NON-TRADITIONAL AGRICULTURAL EXPORT SUPPORT PROJECT

ASSESSMENT OF EL SALVADOR COOLING SYSTEMS  
FOR MELON, SQUASH AND CUCUMBER

Assignment Number: ST/89-13

### DEAD AIR SPACE

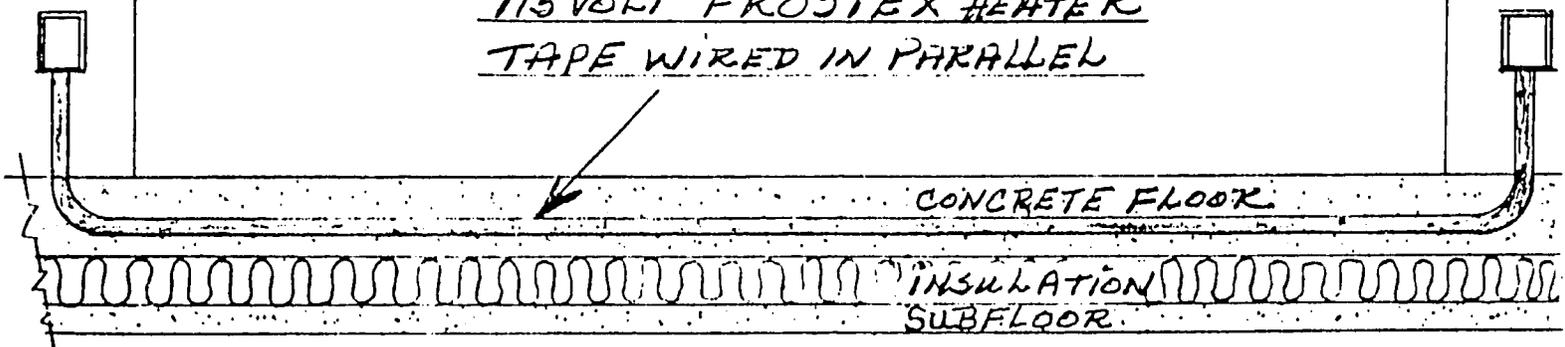
The area between the roof and the insulated ceiling must be power ventilated. Four to five air changes per hour is recommended. An electric powered fan in one end and a fixed vent in the opposite end is required to prevent condensation in this area.

FLOOR WARMER AT FREEZER DOOR ENTRANCE

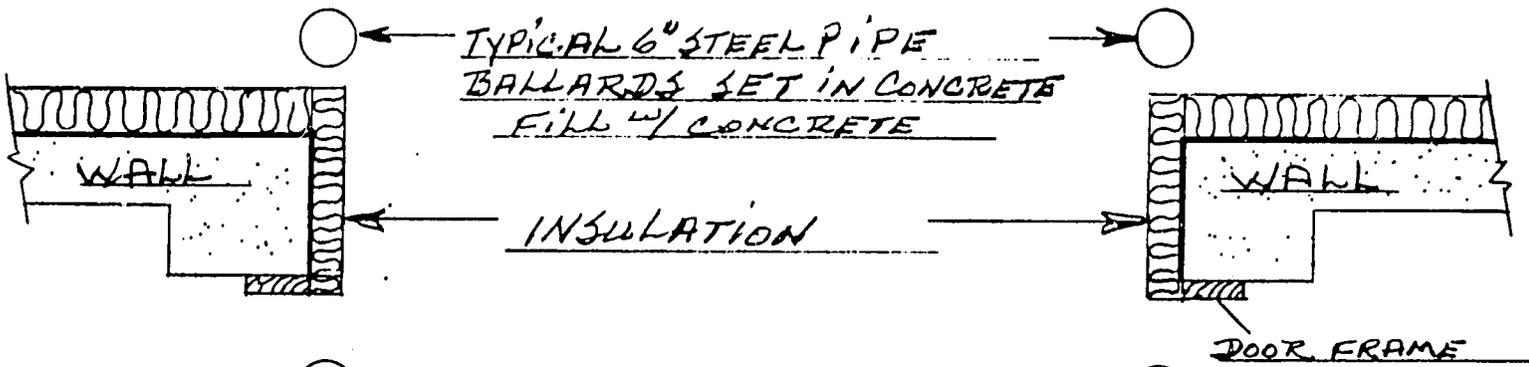
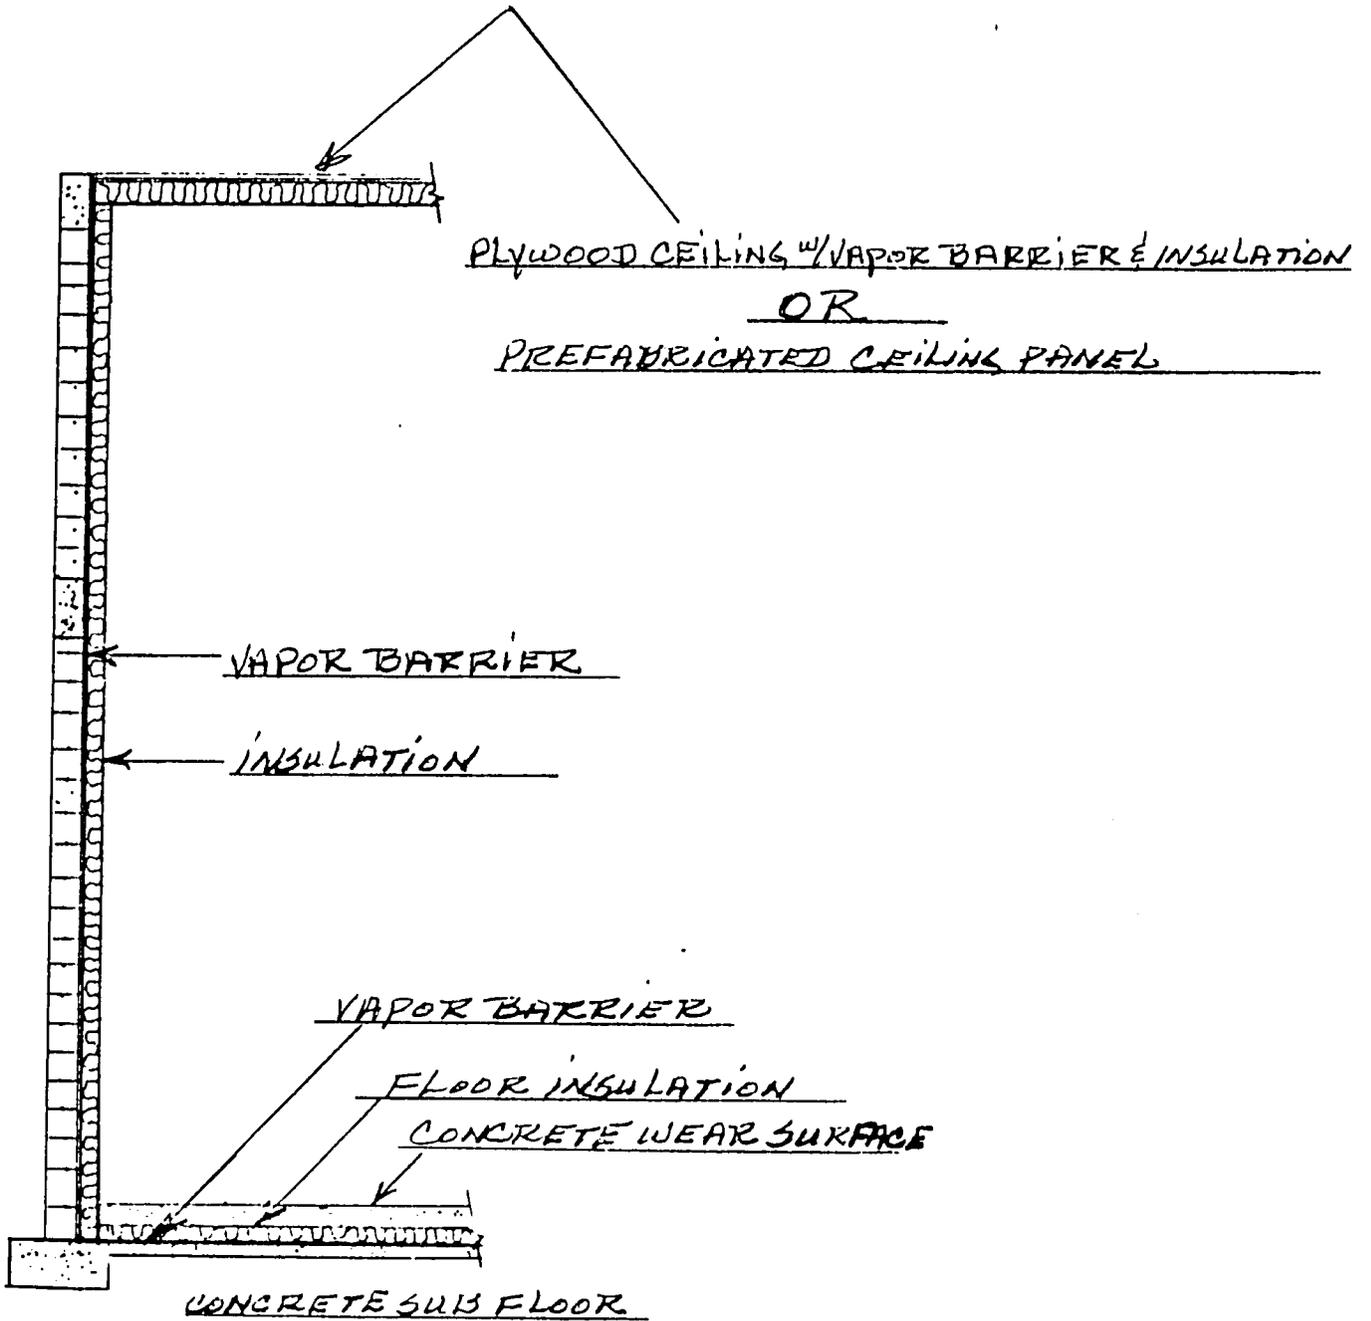
It is unknown at the time of this writing whether or not the floor of the room contains a proper vapor barrier. The wall insulation is being glued in place with a vapor barrier mastic. It was suggested that a mortar mix be floated on the block wall to close up small holes to insure the integrity of the mastic. The ceiling of the room is composed of prefabricated insulated panels. With proper caulking of all joints the insulated panels provide a perfect vapor barrier as well as insulation.

Formed rigid conduit containing tape heaters should be installed in the slab at the doorway. Failure to heat this area will result in ice formation on the concrete in the doorway.

1" RIGID CONDUIT FORMED AS  
SHOWN W/ 4 LENGTHS OF  
115 VOLT FROSTEX HEATER  
TAPE WIRED IN PARALLEL

FLOOR WARMER AT FREEZER DOOR ENTRANCE

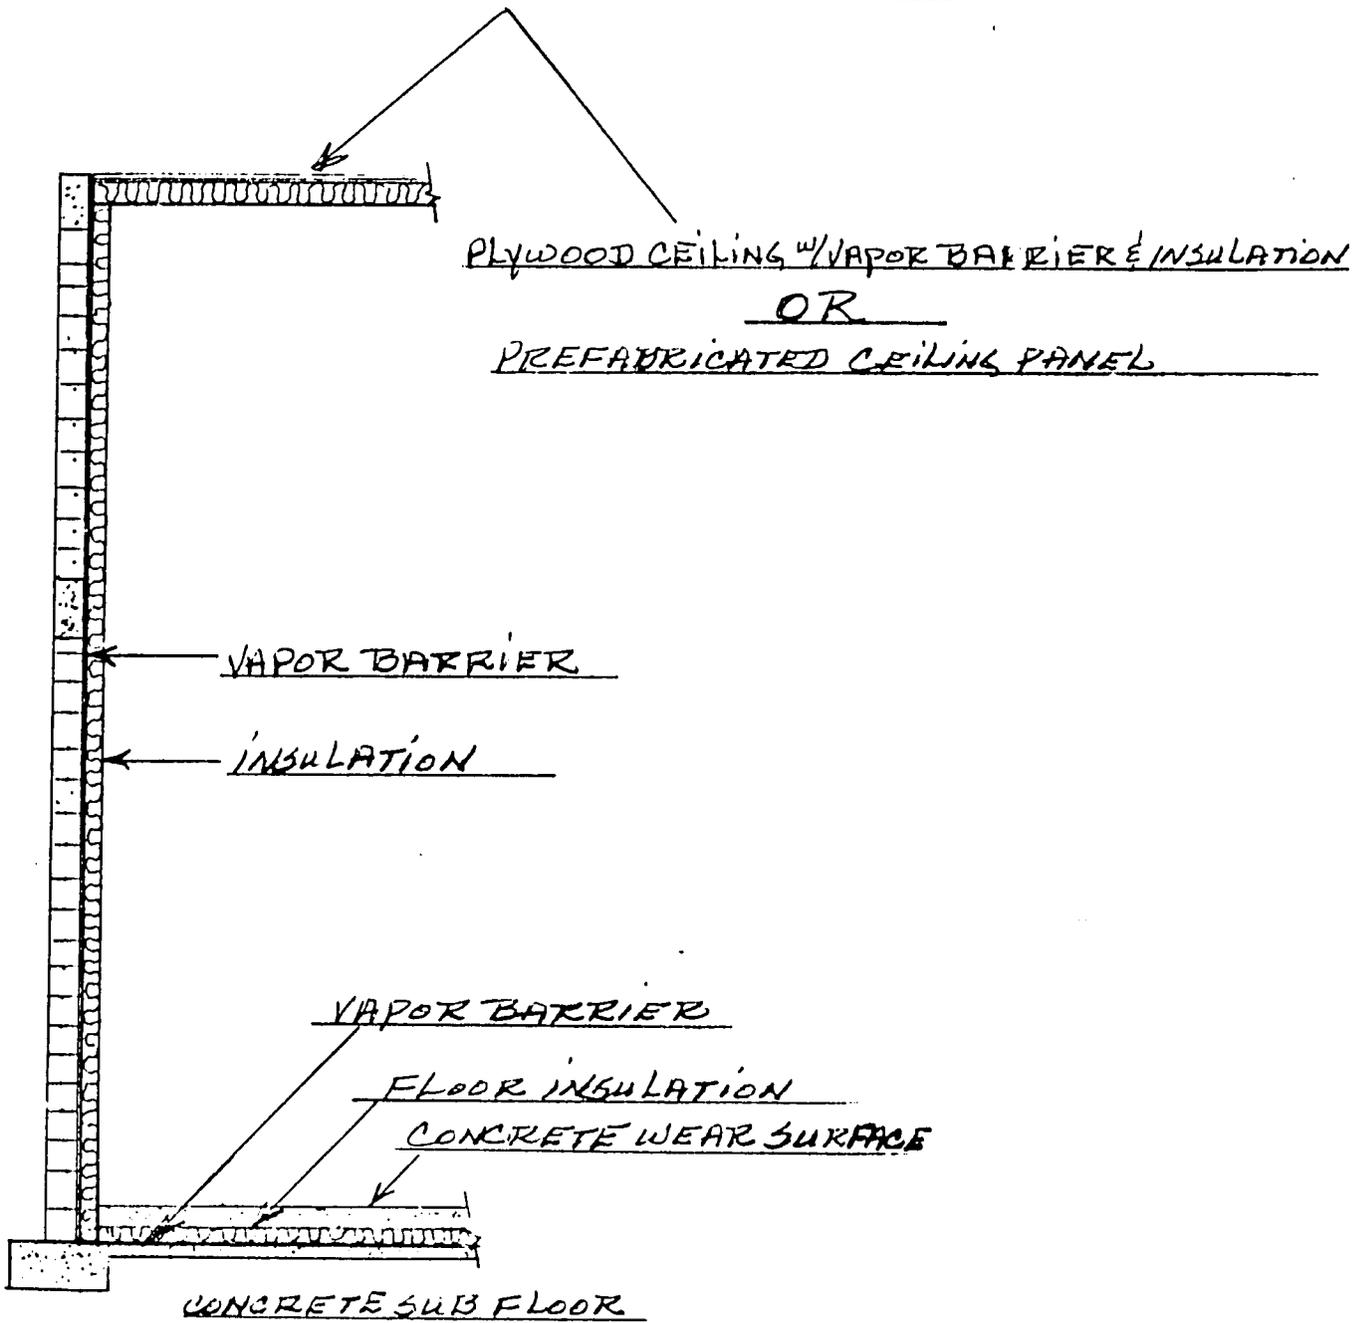
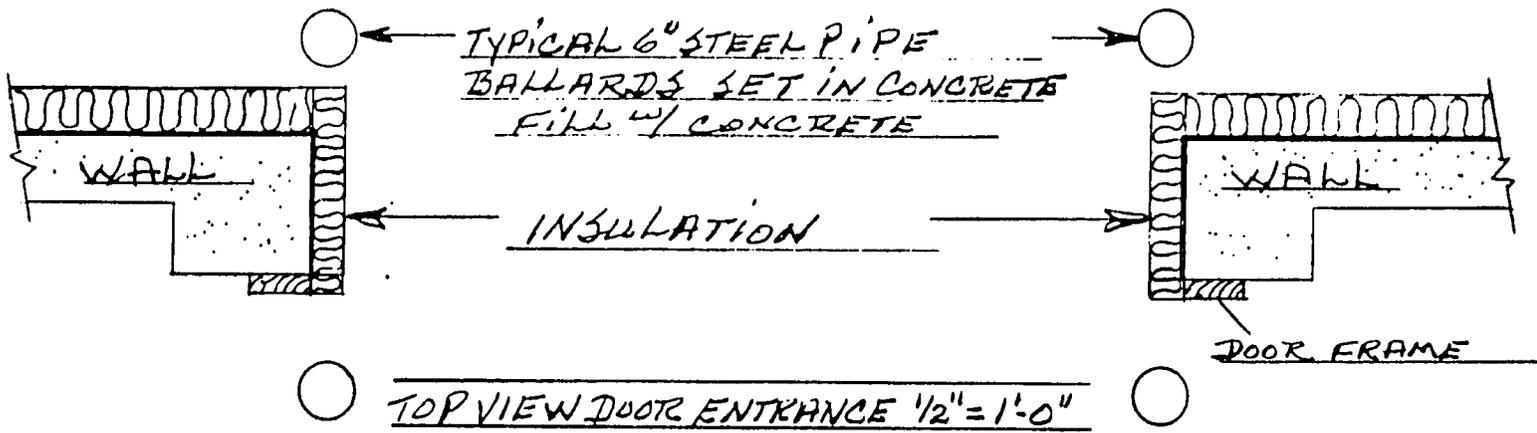
- A. VAPOR BARRIER - Moisture penetration prevention of the insulation is mandatory. Sketches of proper construction techniques are provided with this report.
- B. INSULATION - Insulation is not as critical except from an operational economical standpoint. Inadequate insulation can cause extended compressor operation resulting in higher power consumption and possibly inadequate room temperature reduction. Recommended minimum insulation thicknesses are provided on the accompanying sketches. If funds are available, thicker insulation is advised. Heat that is kept out of the room does not have to be removed by the refrigeration system.

The recommended size and spacing of PVC pipes to prevent substraat freezing is: 4" diameter @ 4' on centers. At Exsalva the 4" diameter pipes @ 8' on center. This may not cause a problem due to the relatively narrow width of the rooms. If funds are available, it is recommended that additional pipes be installed. Formed rigid conduit with tape heaters are recommended to be installed in the doorway slabs where they are subjected to ambient temperatures. Failure to do this will result in ice formation on top of the slab in the doorway.

1" RIGID CONDUIT FORMED AS  
SHOWN W/ 4 LENGTHS OF  
115 VOLT FROSTEX HEATER  
TAPE WIRED IN PARALLEL

EXISTING FLOOR PLAN SCALE 3/16" = 1'-0"

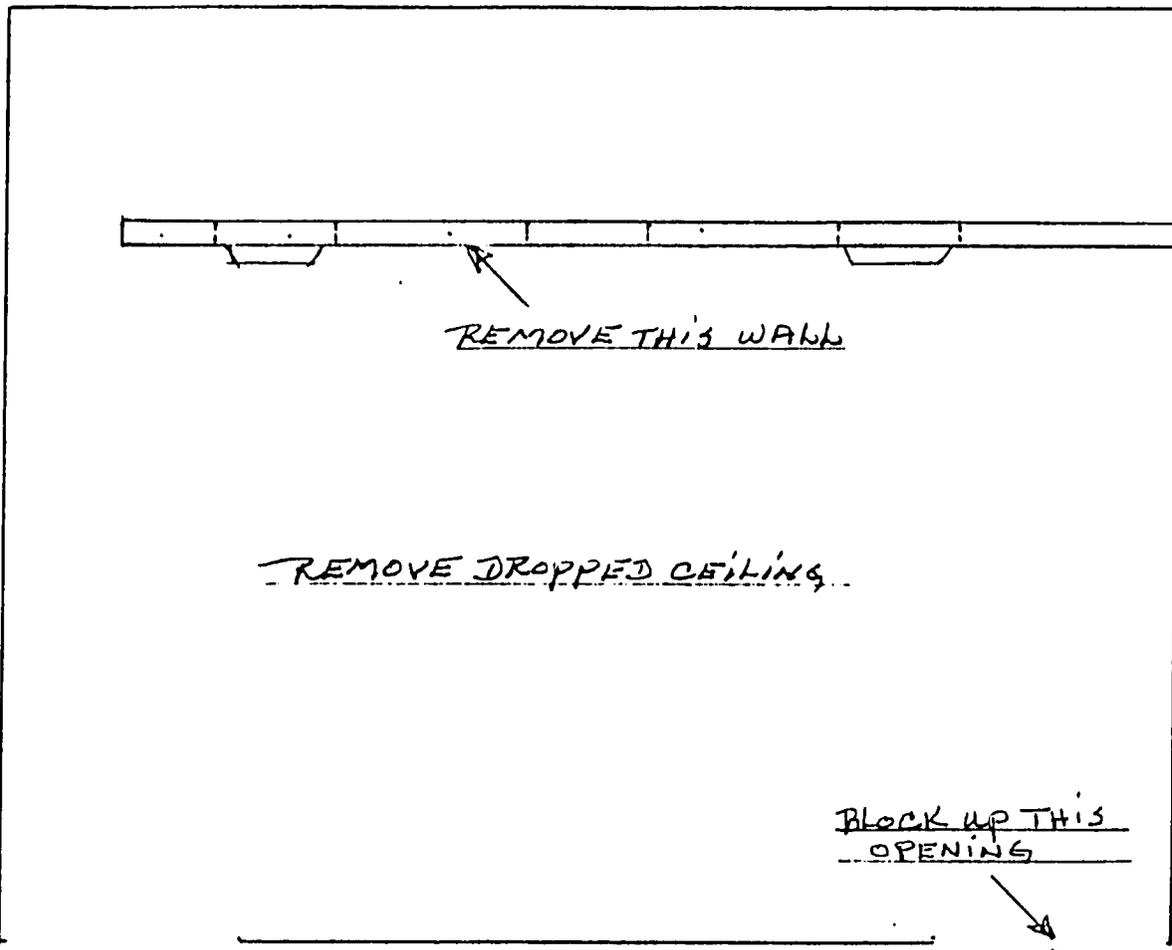
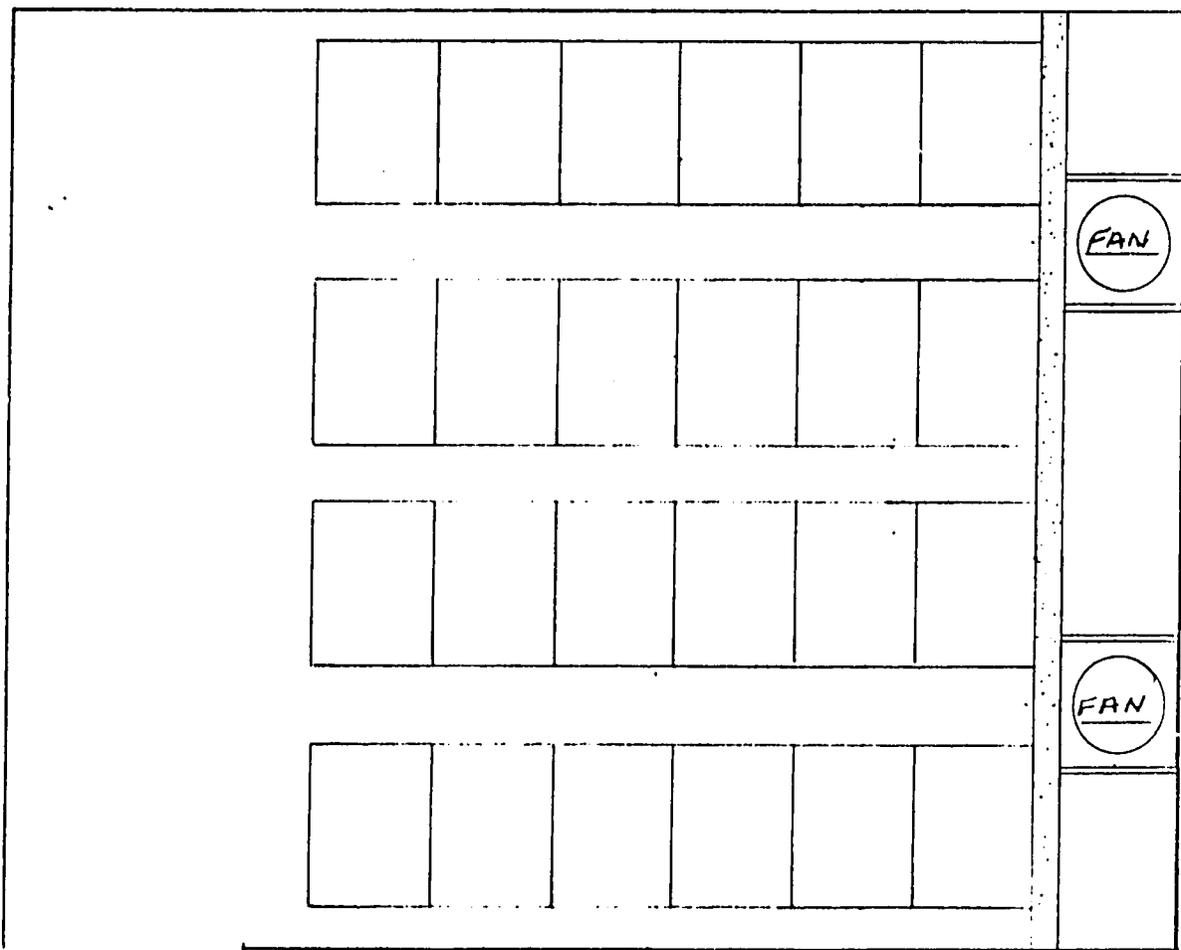
This facility showed good expertise in layout except for the pre-cooling room. The pre-cooler room as implemented will cool melons faster than normal room cooling, but not nearly as fast as a properly constructed forced air system. A sketch is provided on the pre-cooling room as it exists and as it should be.

The refrigeration system is causing some problems due to an imbalance between the capacity of the condensing units and the blower coils. Unfortunately, refrigeration manufacturers do not always post the true ratings for their equipment. This is called "commercialization" by their sales departments. This job was "commercialized" to the point that it is causing problems. This problem can be corrected by adding one additional blower coil to each of the three systems.

NEW FLOOR PLAN SCALE 3/16" = 1'-0"
